Re: Unocal No. 5484 (351812)
18950 Lake Chabot Road, Castro Valley, California
ACEH Fuel Leak Case No. RO0000352
GeoTracker Global ID T0600101453

**Subject: Chabot Creek Findings Report
Unocal No. 5484 (351812)
18950 Lake Chabot Road, Castro Valley, California
Fuel Leak Case No. RO0000352
Geotracker Global ID # T0600101453**

Figure 1: Receptor Map

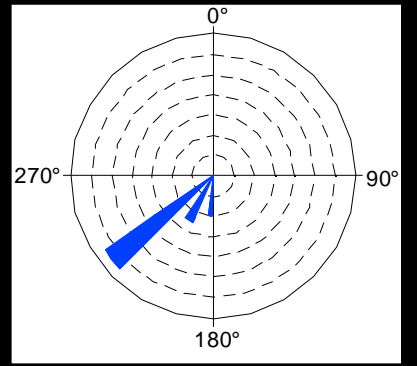
Shallow groundwater observed at the site would likely intercept the unlined creek if it was within 200 feet of the site.

Contradictory statements between drained or buried sections of Chabot Creek vs. closest sections of Chabot Creek.

Response: There is no unlined creek section within 200 feet, the only remaining feature related to Chabot Creek is the lined culvert that was installed in 1961 which is 580 feet downgradient of the site, see **Attachment C, Figure 1 and Figure 2**.

Response: The current status of Chabot Creek is clarified in **Attachment C**.
